CONSERVATION TEAM CONSULTATION APPLICATION RESPONSE

APPLICATION REF:	26/00524/FPH & 26/00525/LBC
CASE OFFICER:	VW
APPLICATION SITE:	The Thatched Cottage, Smiths End Lane, Barley, Royston, Hertfordshire, SG8 8LH
DESCRIPTION OF WORKS:	Single storey rear extension, open-sided side porch following demolition of existing side porch and C20th store. Alterations to external materials and fenestration throughout. Erection of detached double garage and installation of no.2 ASHP following removal of existing oil tank (as amended by drawing nos. 2541.PD.201E and 2541.PD.202D received on 21 May 2026) Single storey rear extension, open-sided side porch following demolition of existing side porch and C20th store. Alterations to external materials and fenestration throughout. Internal alterations (as amended by drawing nos. 2541.PD.201E and 2541.PD.202D received on 21 May 2026)

SIDE SOUTH-EAST ELEVATION

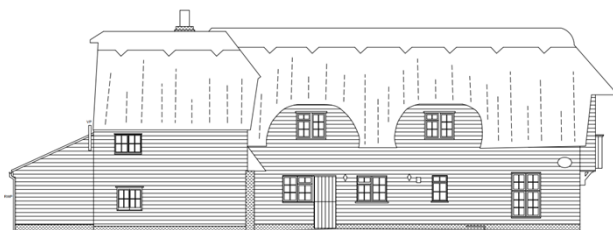
These comments relate to amended drawing nos. 2541.PD.201E and 2541.PD.202D received on 21 May 2026 following the concern I raised on 6 May regarding the fenestration between the two pairs of part-glazed doors on the South East Elevation. I suggested that the glazed screen be replaced either with a double-casement window (red outline below) or maybe a triple casement, as this would maintain a greater cottage aesthetic and where two double-door openings are already proposed.
